Addendum No. 5

Project: Salem Community Schools
2021 FEMA Safe Room Additions

Project No.: 202020.01/02

Date: May 3, 2021

AD-5a

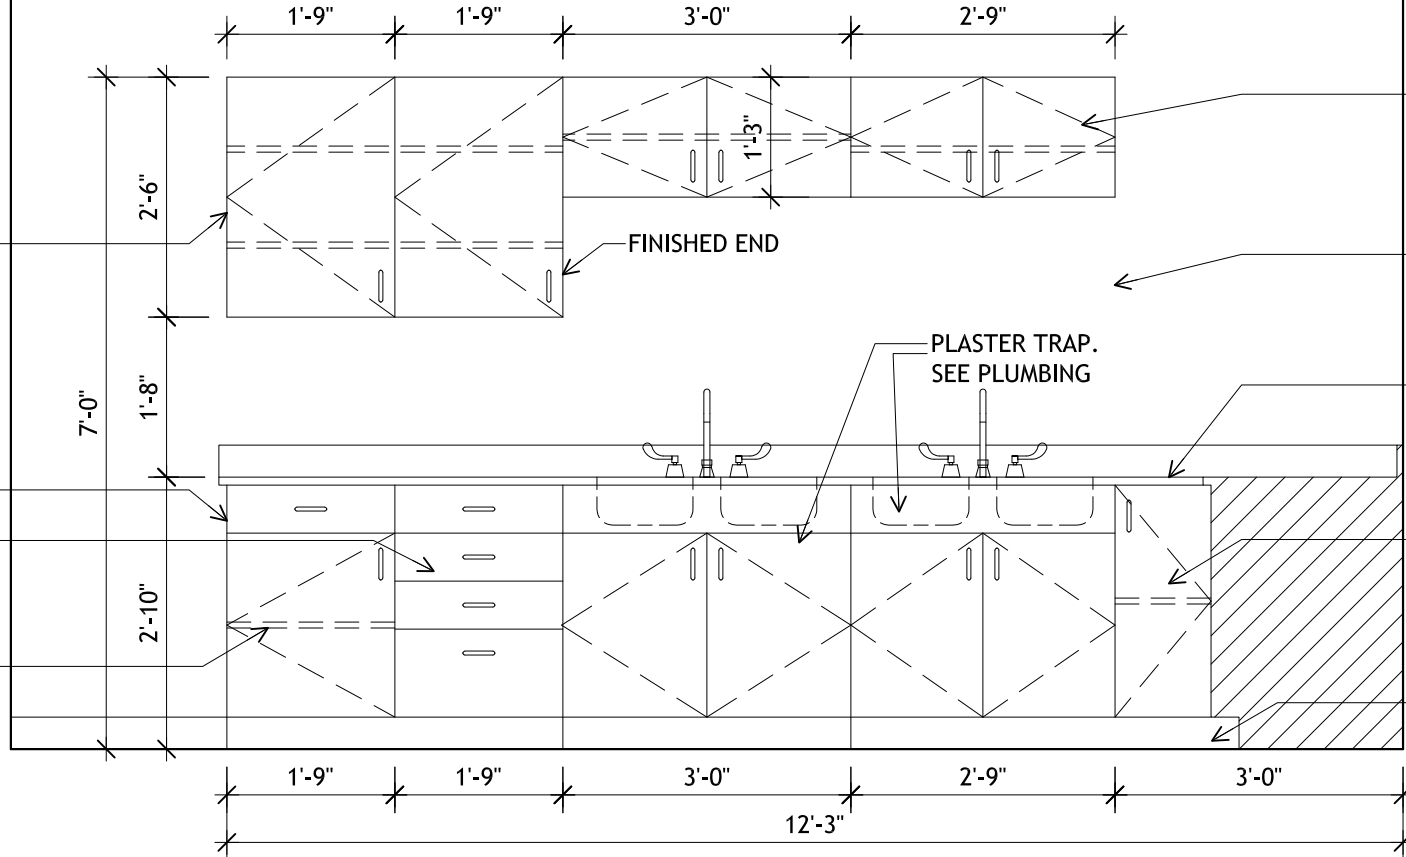
23. Drawing Q-201 - Prep Area B103 Casework Elevation: revise Elevation per attached drawing AD-5a.
24. Drawing I101:
Specialty TS: Replace "shudder" with "shutter".
Storage B105: Replace "AC1" with "Exposed Structure".
Revise Finish Schedule and Finish Plan per attached drawing AD-5b.

1
AD-5c Expansion Joints - North
full size plot scale: 1/16"=1'-0"

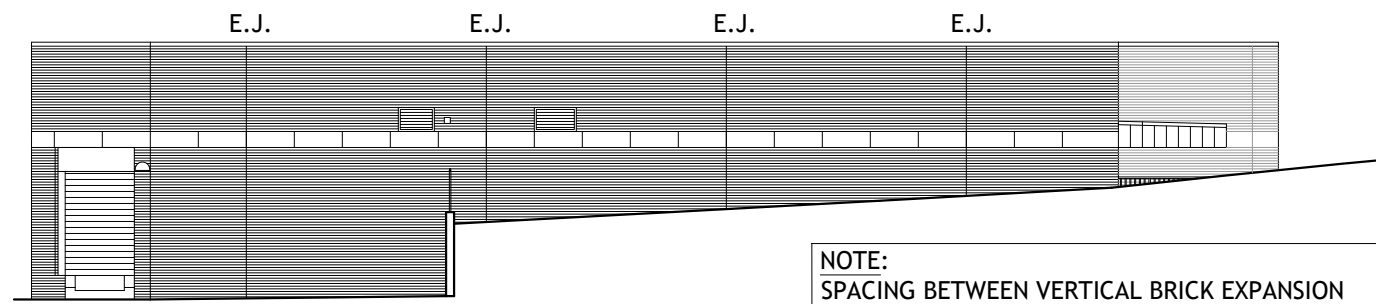
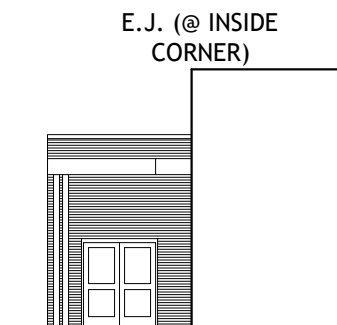
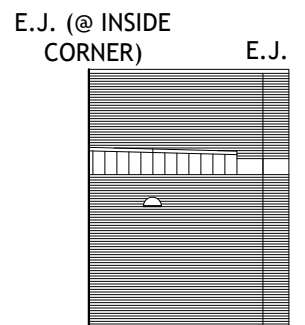
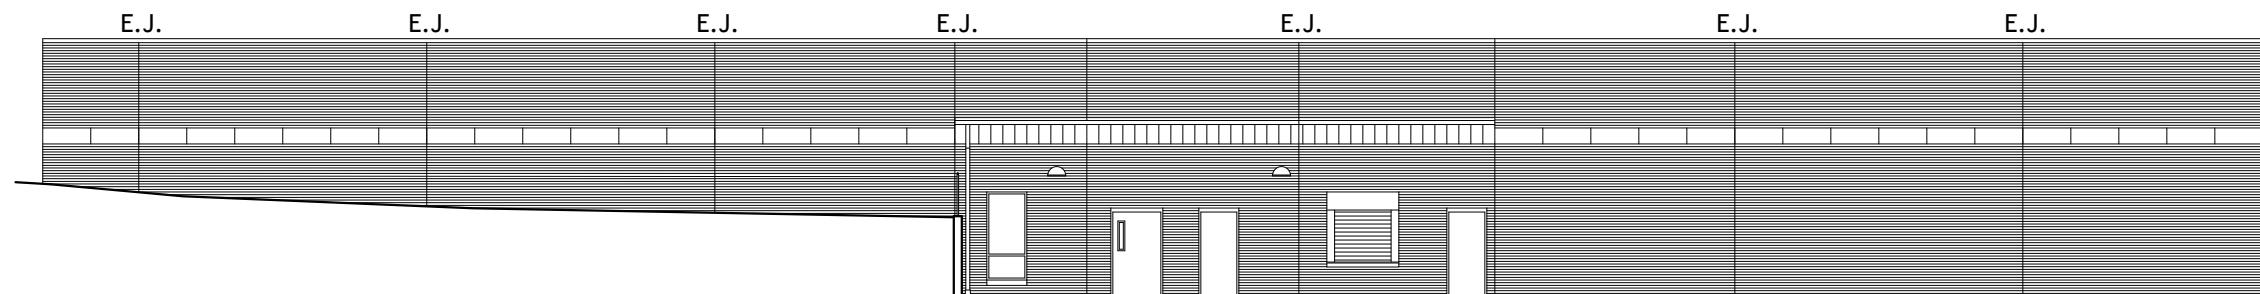
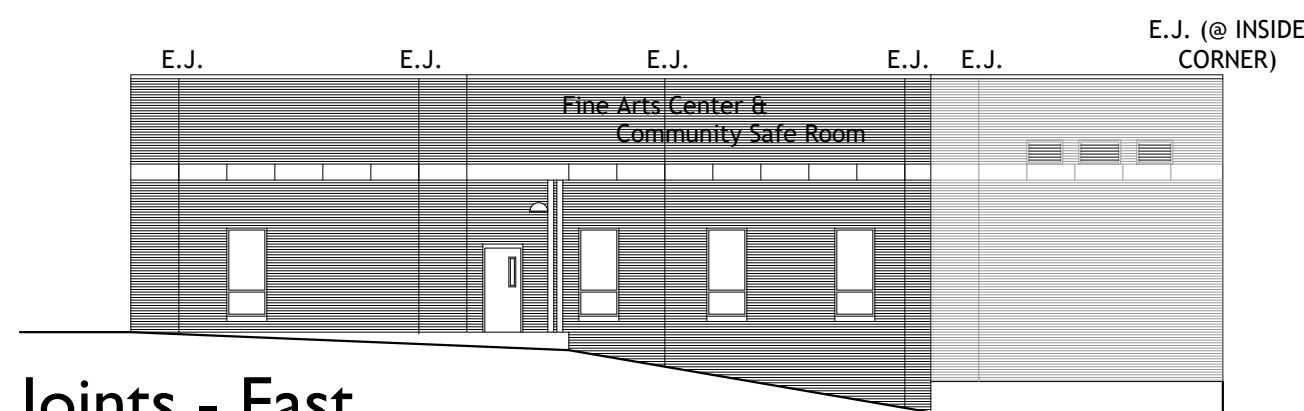
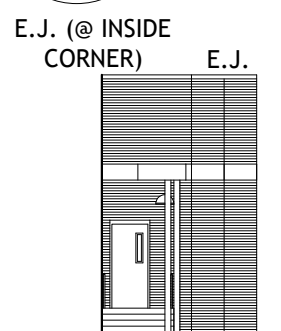
10. Drawing A201 - Add R6 soap dispenser and R8 paper towel dispenser at new hand wash sink in Concessions 121.
11. Drawing A501 - Refer to attached Drawing AD-5c for brick expansion joint locations.

NOTE:
SPACING BETWEEN VERTICAL BRICK EXPANSION JOINTS SHALL NOT EXCEED 25'-0" IN AREAS WITHOUT OPENINGS AND 20'-0" IN AREAS WITH OPENINGS. COORDINATE EXPANSION JOINT LOCATIONS WITH LIMESTONE ACCENT BAND JOINTS.

1
Concessions 121 Elevation
Q-201 full size plot scale: 1/2"=1'-0"

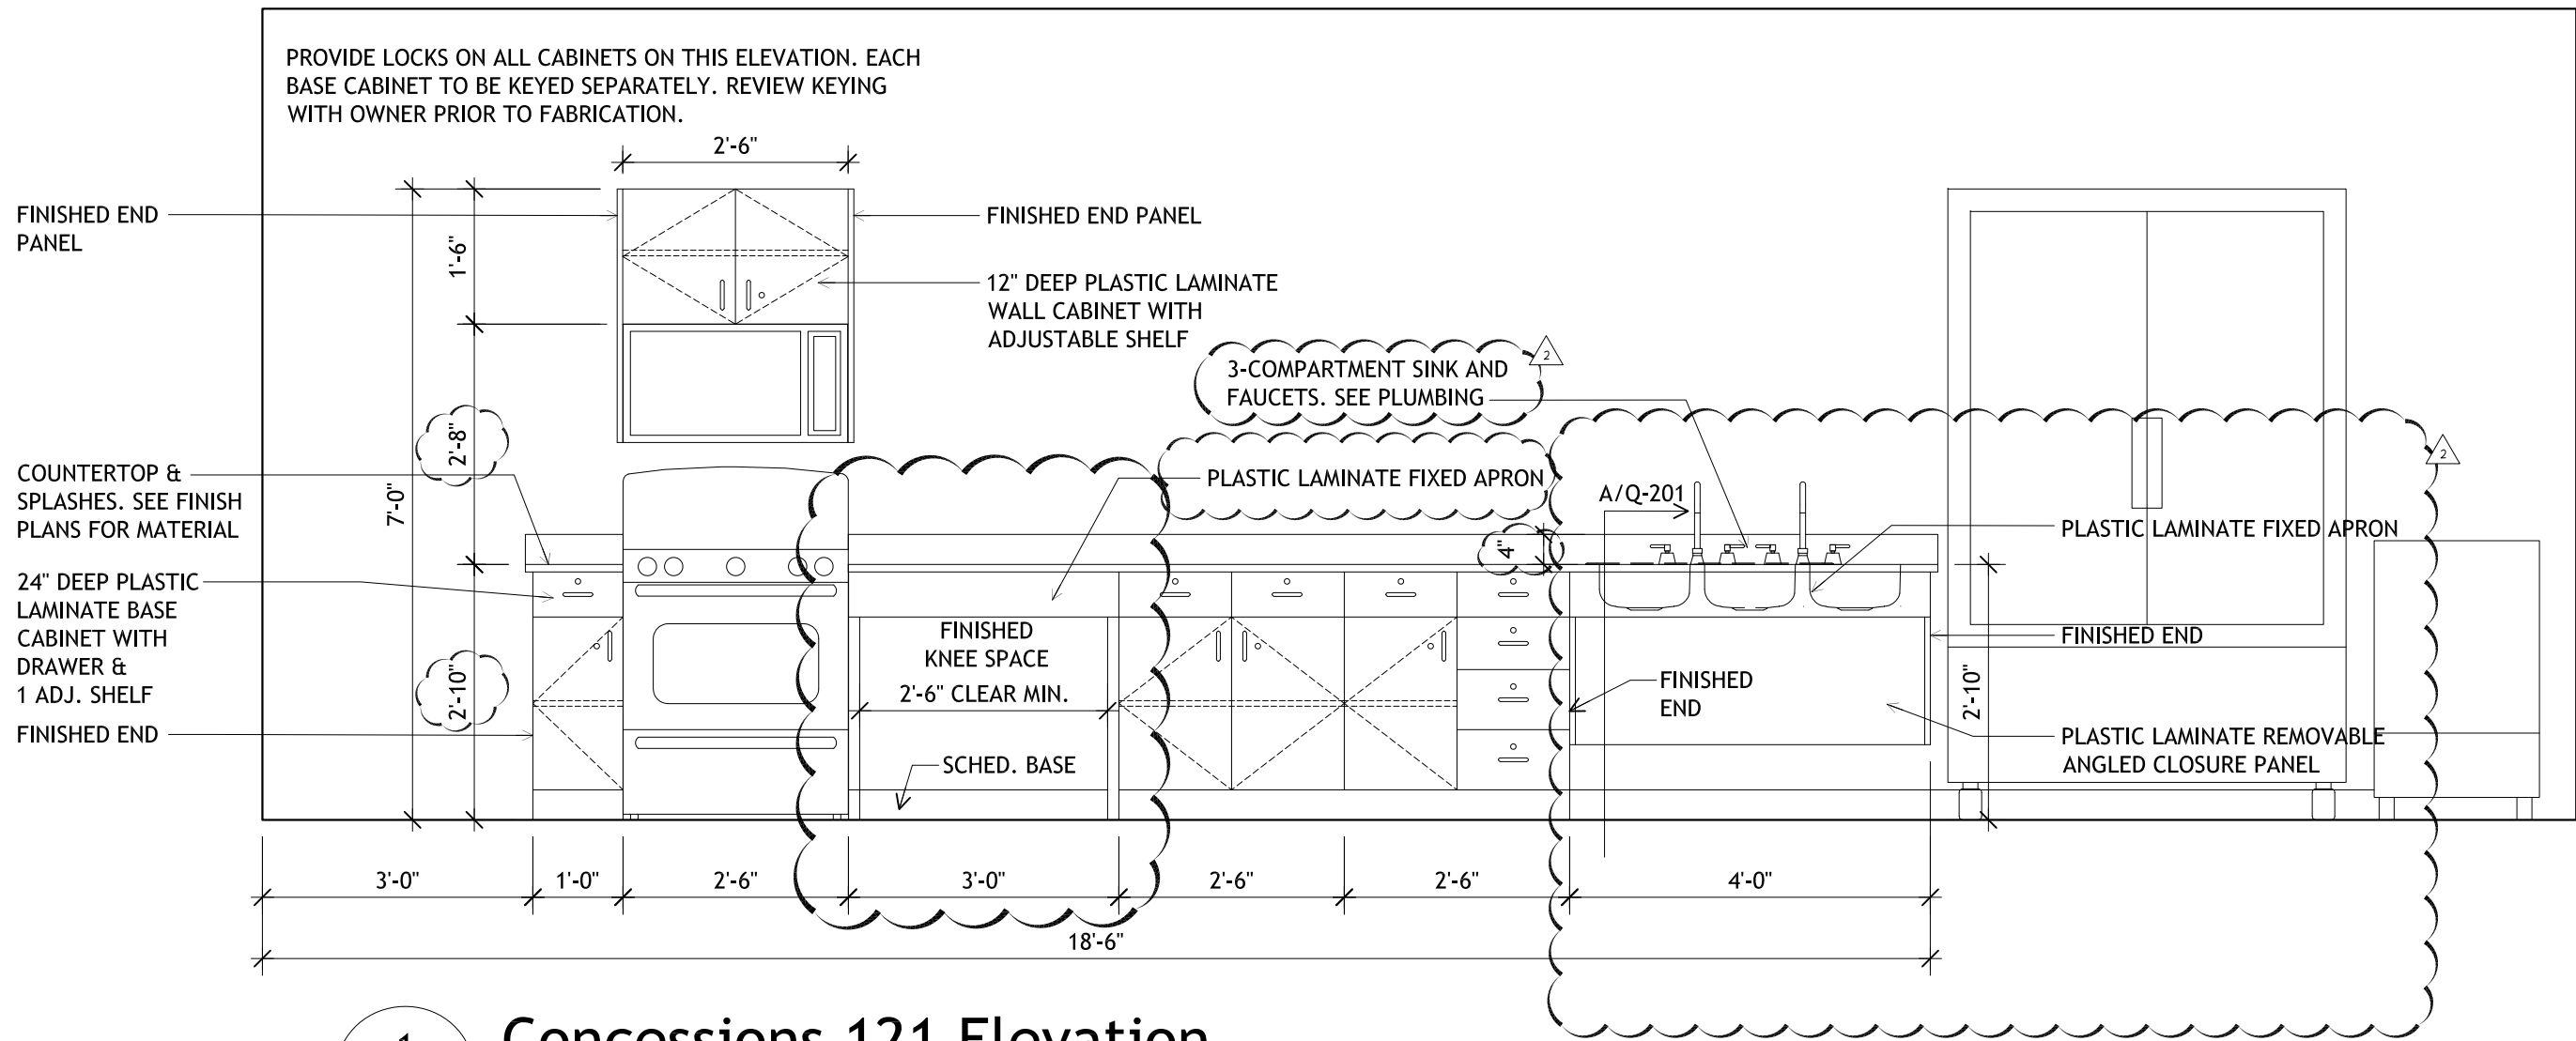
14. Drawing Q201 - Replace Elevation 1 per attached Drawing AD-5d. Changes have been made to accommodate 3-bowl sink.

Sheet
AD-5e

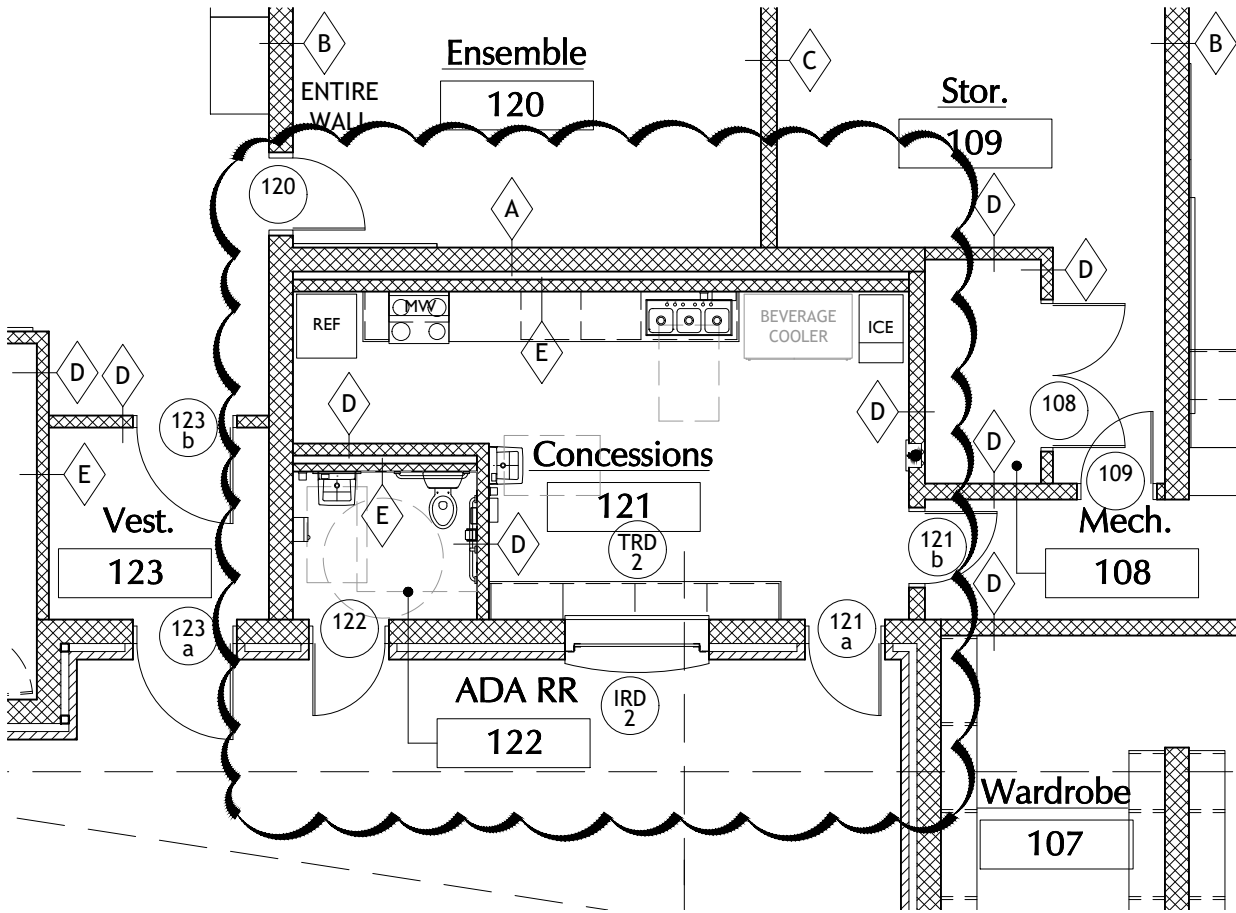
8. Refer to attached Drawing AD-5i for concrete head wall detail.
9. All Floor Plan Drawings - Concessions 121: Add a hand wash sink and replace the 2-bowl sink with a 3-bowl sink as shown on attached Drawing AD-5e. Refer to STW addendum items for additional information.
